CALLISON

April 12, 2012

Re: Chase – Cedar Oak & Willamette, 19080 Willamette Drive, West Linn, OR
210461.89
Class II Design Review Application (DR-12-08 et al) – Completeness Review Response

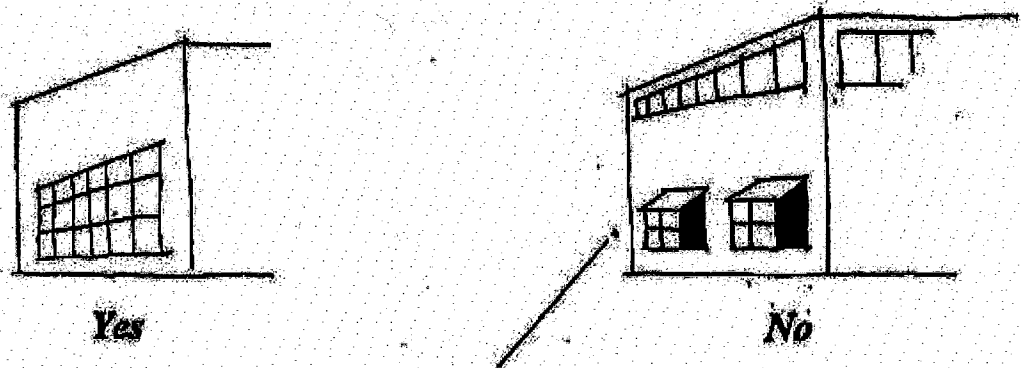
55.100(B) (3) requires that the topography and natural drainage shall be preserved to the greatest degree possible. The applicant needs to discuss the ten foot difference in grade at the rear of the site and what kind of grading will take place in this sloped area.

This requirement appears to have been created in order to limit impact of development on undeveloped lands and their drainage patters. The site was home to a nursery and the majority of this site has already been impacted by previous development. The front half of the site slopes gently away from Beaverton-Hillsdale Hwy and then slopes downhill more steeply along the north and south sides of the existing Kasch's Nursery building. The existing building itself is stepped to

match the slope. There is a lower flat area behind the Kasch's Nursery building that is 20'-30' wide before sloping downhill again toward the rear property line.

Grading proposed is to the minimum extent necessary to develop the site. Proposed grading will not alter existing drainage patterns as the site will still slope downhill and away from Beaverton-Hillsdale Hwy toward the rear property line. Beyond the drive-thru bypass lane the site grading has been adjusted to provide for a relatively flat area approximately 3' wide (typically). The flat area was created to allow for 4' tall solid wood screen fence to be located near the edge of the drive-thru lanes for the purposes of screening the drive-thru, as requested by the City. Beyond the fence line the site will be graded at a 3:1 slope until the grading matches the natural grade. The 3:1 slope area will have trees and shrubs planted on near the fence to provide additional vegetative screening once landscaping matures. Beyond the fence the slope will also be landscaped with salal which will provide slope stability and will eventually grow to blanket the slope and the remainder of the rear of the site.

1 SITE PLAN

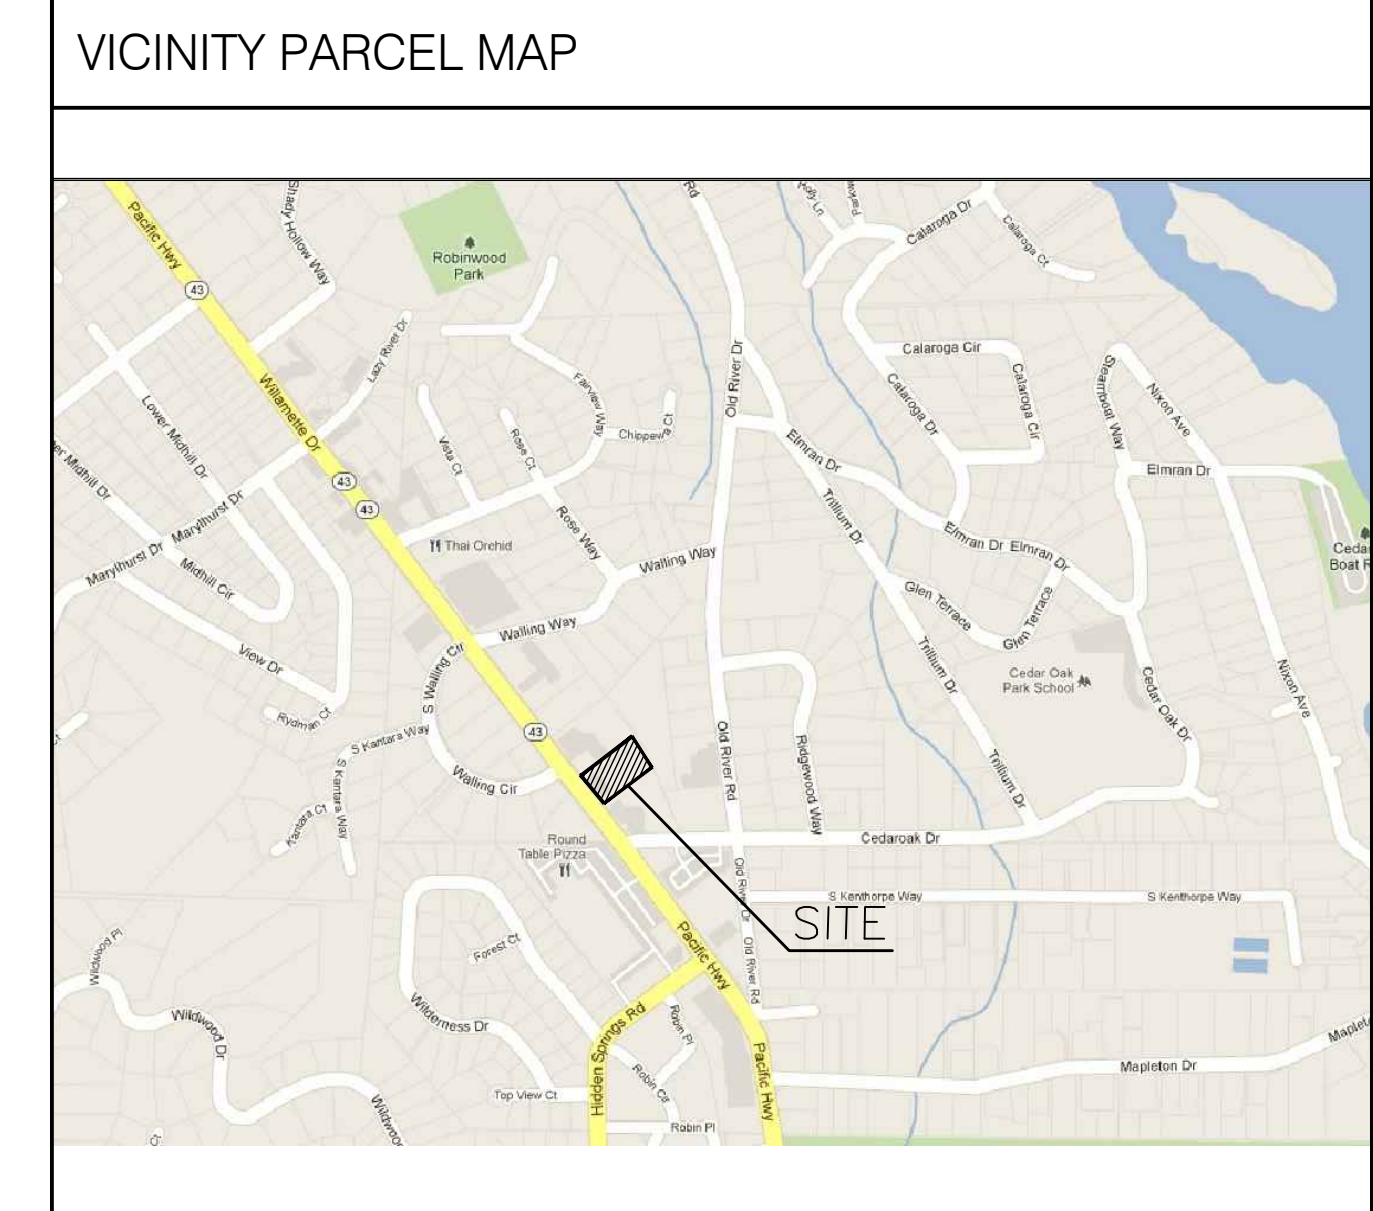
55.100(B)(7)(d) requires that "*accessways, parking lots, and internal driveways shall accommodate pedestrian circulation and access by specially textured, colored, or clearly defined footpaths at least six feet wide. Paths shall be eight feet wide when abutting parking areas or travel lanes*". The applicant should show a pedestrian walkway from the rear parking stalls to the rear entrance and further

Staff also notes a lack of pedestrian facilities that would allow pedestrian access between the bank and the properties to the north and south and between the rear parking area and Willamette Drive as required per 55.100(B)(7)(e). With the current design pedestrians at the rear of the bank (customers, employees) will be forced to walk in the travel lanes/driveways or across landscaping if they want to access neighboring businesses or Willamette Drive.

Glare has not been discussed. Staff is concerned about glare from vehicles approaching the drive through tellers/ATM and the impact on residences to the east. Mitigation may be required in the form of a solid four foot high wood fence or CMU wall at the east edge of the drive through lanes to block glare and also diminish noise levels to meet DEQ standards. Relying solely on vegetation for noise/glare mitigation is impractical since the trees selected will take years before they provide even a modicum of screening.

55.100(G) Delineation of the rear of the site by a fence is needed to identify that area as a private space.

We have added a cross-walk style striped pedestrian walkway connecting from the four compact stalls across the drive-aisle to the accessible aisle between the two ADA spaces. Please note that as discussed we were not able to shift the ADA access stalls and aisle closer to the entry due to the landing area required for the accessible ramp serving the accessible stalls.

As we have reviewed over the phone and via sketches sent via e-mail, we have revised the walkways at the rear of the building to extend to the north property line and to the edge of the shared access drive at the south side of the site. Note that where adjacent to parking stalls the walkway measures 8' in width in consideration of possible vehicle overhang. Where not adjacent to parking the walkways are 6' in width.

As discussed we have added a less formal walkway along the south edge of the building to allow connectivity from the public sidewalk at Willamette Drive to the walkways at the rear of the site. This walkway is 4' wide and will be constructed of compacted crushed limestone, compacted decomposed granite, or concrete; depending on Chase's preference. Note the plan represents a concrete walk; however, final materials will be selected when construction plans are prepared.

As requested the site plan has been adjusted to provide a 4' solid wood fence for screening the drive-thru area to mitigate glare from vehicles approaching drive through tellers/ATM. Note: As discussed in the description of site grading earlier in this response letter, grading adjacent to the drive-thru lanes has been adjusted to provide a relatively flat (max slope 4:1) area for the fence to be constructed on before the slope breaks away downhill from the fence line.

A chainlink fence has been called out on the site plan along the rear property line. Final details for fence material will be included in Final Site Development plans. Final fence line location will need to be field verified due to several trees being located along or on the rear property line.

SOUTH ELEVATION SCALE 1/4"=1'-0" 1

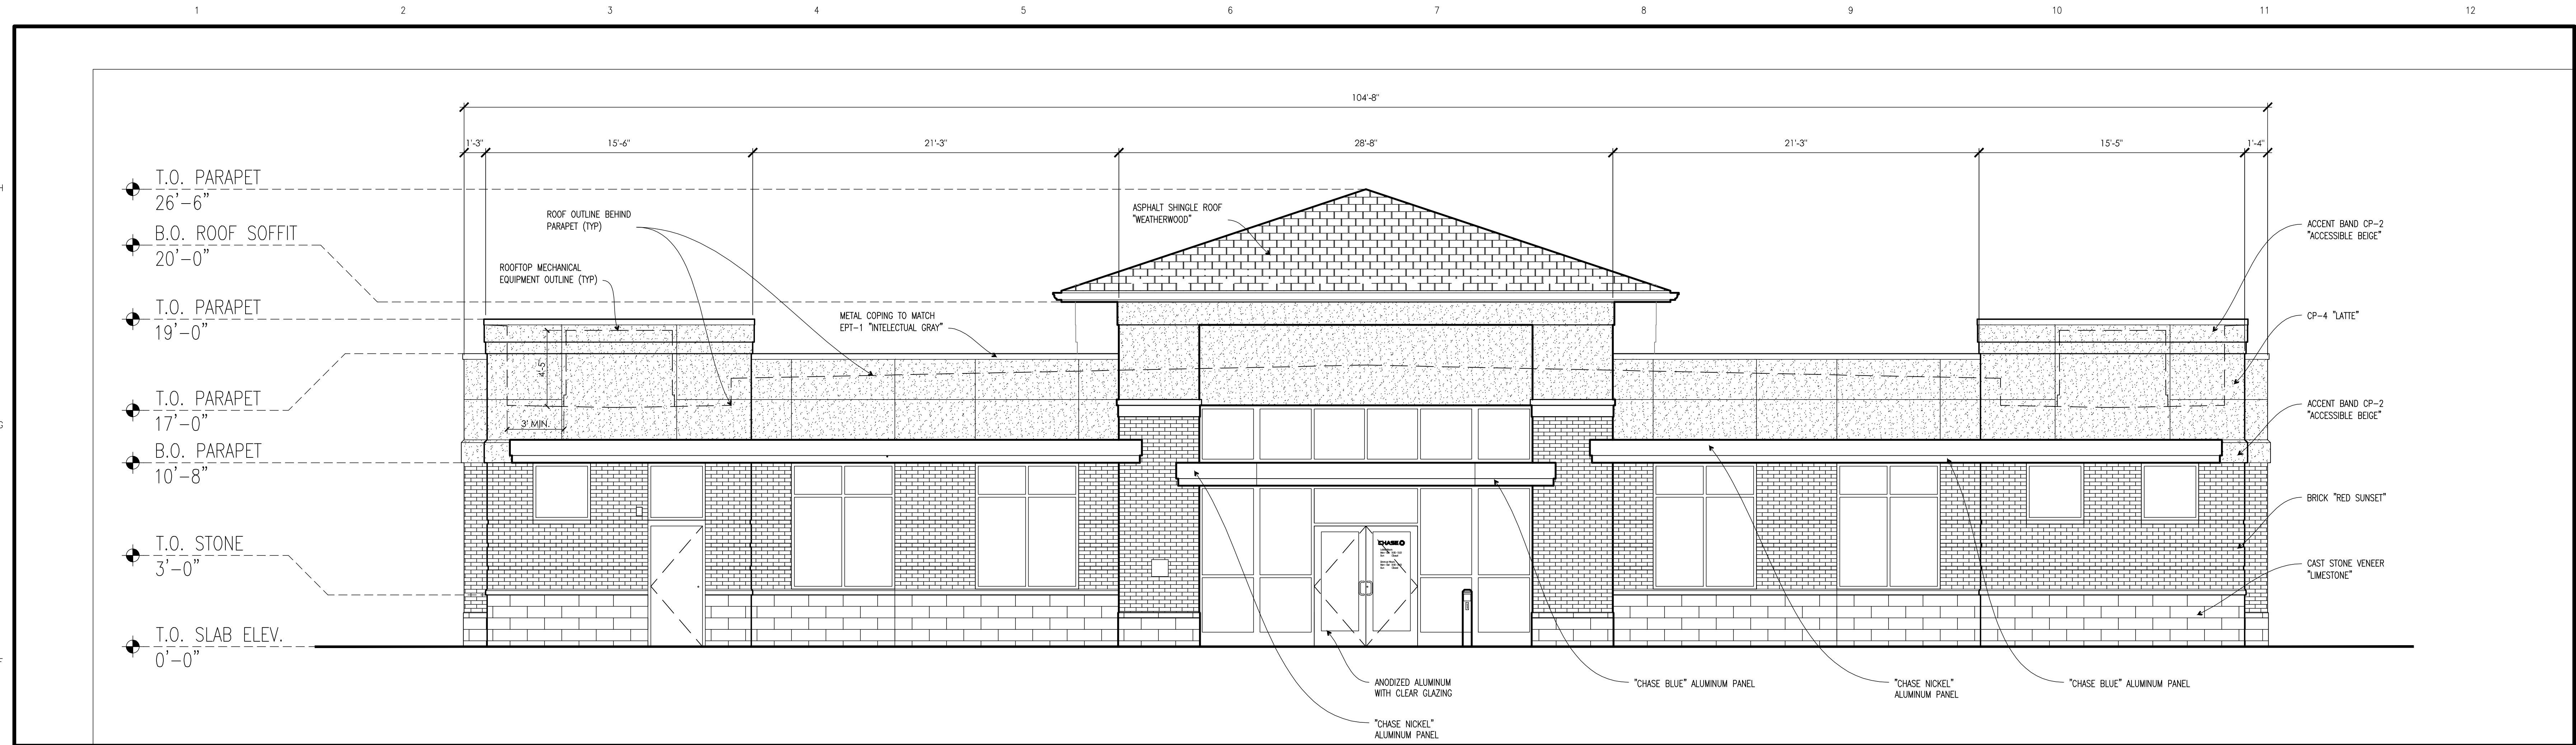
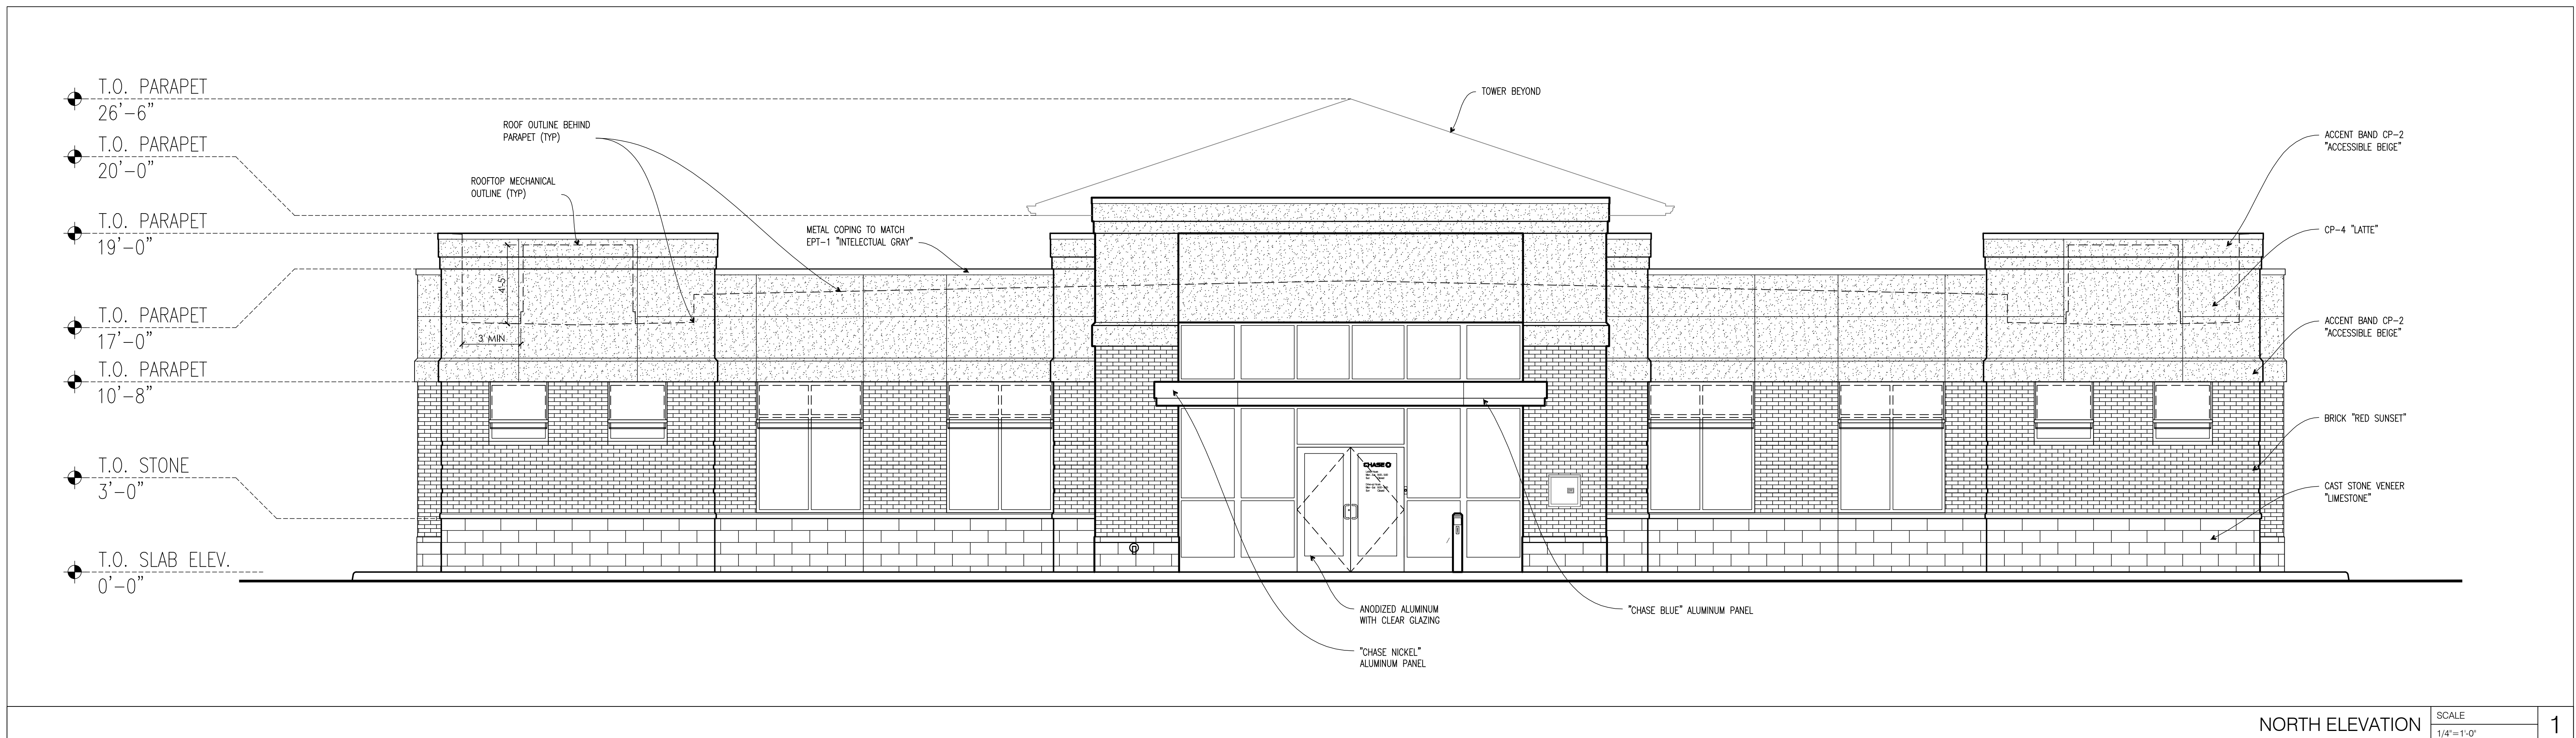
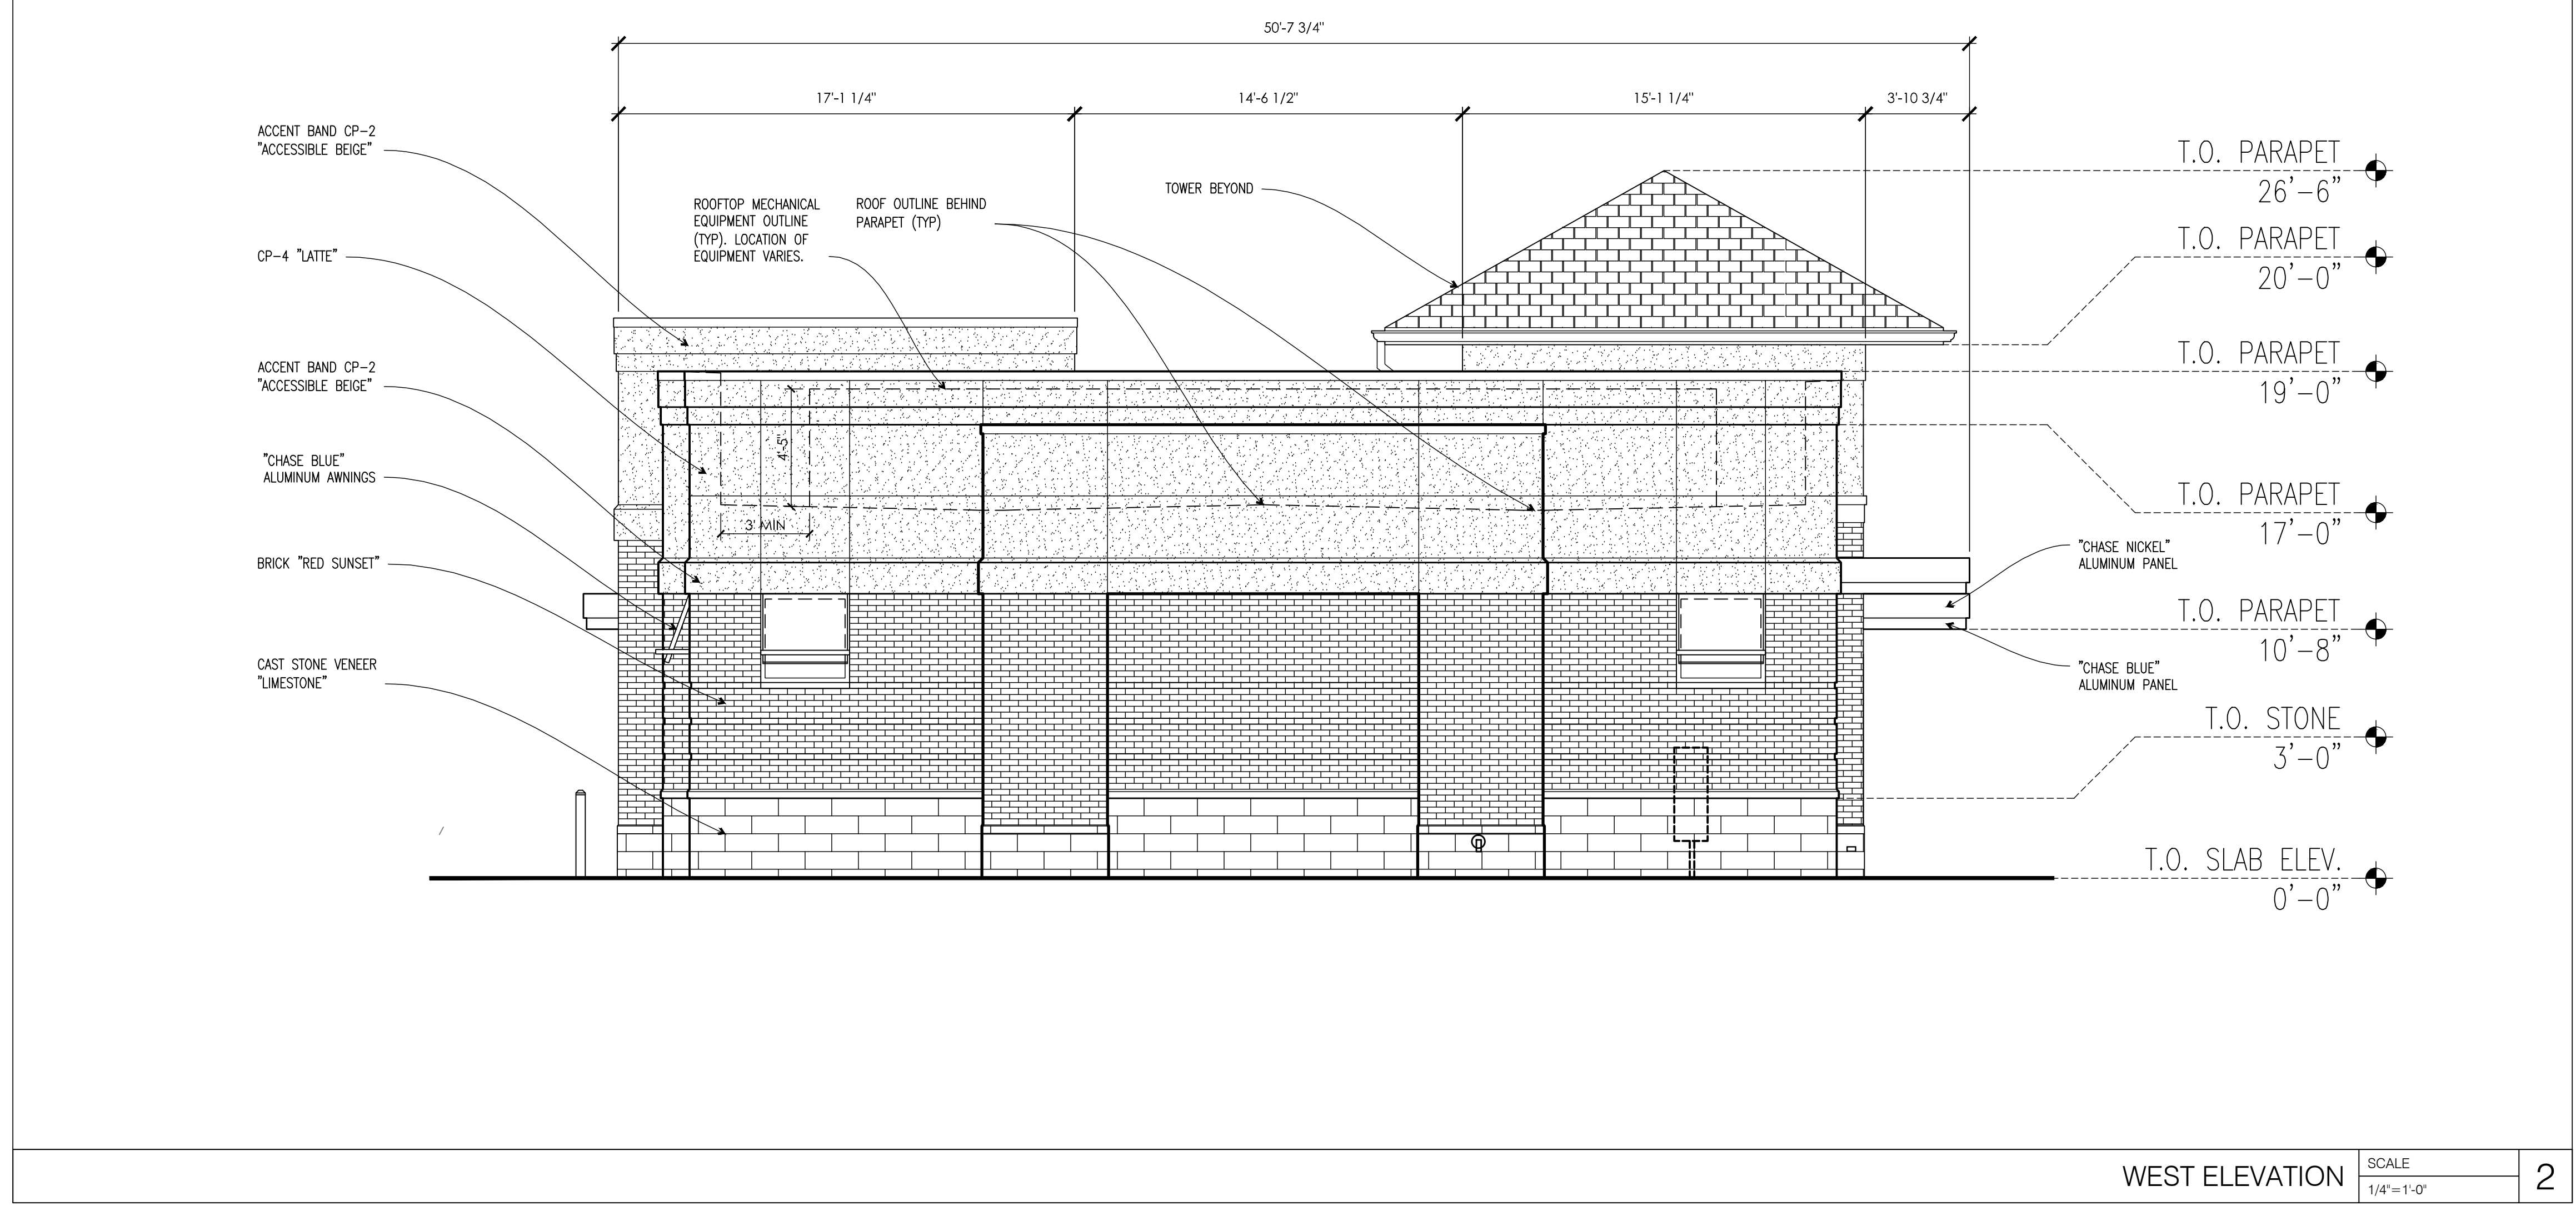
*55.100(B) (6) (f) Transparency. This section requires that 60 percent of the lineal frontage of the street facing elevation comprise pedestrian level windows. The applicant contends that transparency is measured in terms of square footage, and not in lineal feet. The applicable section is as follows:

The City of West Linn has interpreted this section to mean that transparency is measured in lineal fashion only and not in terms of square feet. The front and rear elevations show pedestrian level transparency amounts of 41% only. That is below the requisite 60%. The two side elevations that need 30% transparency per code provide 0% each. Staff recognizes the functional requirements of a bank and that certain areas must be secure. Even if some additional windows were added, the bank is so far from the required amount that a Class II Variance should be applied for.

The front façade is 102' long which would require 61'-2" of transparency. Side elevations both are visible from the highway. The side elevations are each 43' long, which would require 12'-11" of transparency per elevation for a total of 25'-10". Overall the project is required to provide 87 lineal feet of transparency.

The proposed front façade has four 6' wide pedestrian scale windows and a 19'-4" storefront window/door system at the entry; providing 43'-4" of transparency. The two clerestory windows provided on each side elevation do not meet the definition of pedestrian scale windows and therefore do not count toward the transparency requirement.

Because code does not fully exempt rear elevations from the requirement to provide transparency we believe the rear elevation should be allowed to be considered as a qualifying elevation for the purpose of transparency transference in the same manner as front and side elevations are considered. The rear elevation is not visible from Willamette Drive. Therefore, 100% of the transparency provided on the rear of the bank should be transferable for the purpose of meeting the transparency requirements for the two side elevations and the front elevation. The rear elevation has four 6' wide pedestrian scale windows and a 15'-9" storefront window/door system at the rear entry; providing 39'-9" of transparency.

If considering glazing transference as allowed by code, the qualifying transparency provided at the front and rear elevations, combined, provide 83'-1" of transparency for the project as a whole, which is only 4'-11" (5.6%) shy of meeting the requirement of 87'.
